# IMMINGHAM EASTERN RO-RO TERMINAL

Applicant's Response to CLdN's Deadline 5 Submissions  
Document Reference: 10.2.52  
APFP Regulations 2009 – Regulation 5(2)(q)  
PINS Reference – TR030007  
November 2023

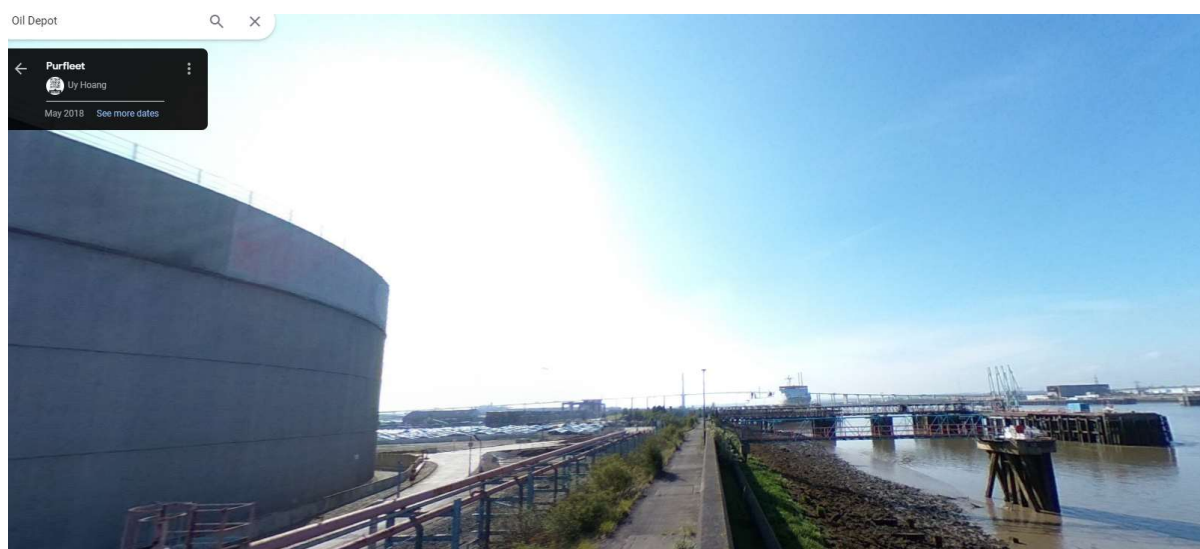
- 3.5 CLdN also make the following statement with respect to **[REP4-009]**: “*The ‘Purfleet Oil Storage COMAH Site’, identified by the Applicant, handles fuel delivered by pipelines, not vessels*”. The Applicant would question whether this is actually correct. The Purfleet Oil Terminal is operated by Esso and does not appear to be a pipeline only facility. The site is a COMAH site and has two jetties with loading arms for oil transfer. The image below shows the eastern jetty of the Esso Purfleet Oil Terminal, with loading arms clearly visible. Ro-Ro vessels moored at CLdN can also be seen, as can the car and container landside operations in proximity of the Esso oil storage tanks.

- 3.6 CLdN also make the statement that: “*The ‘oil jetty’ the Applicant is showing the distance/proximity of 130m upriver in this example is a CLdN jetty, which does not handle oil*”. The image above would lead the Applicant to question this statement and would welcome further clarification.
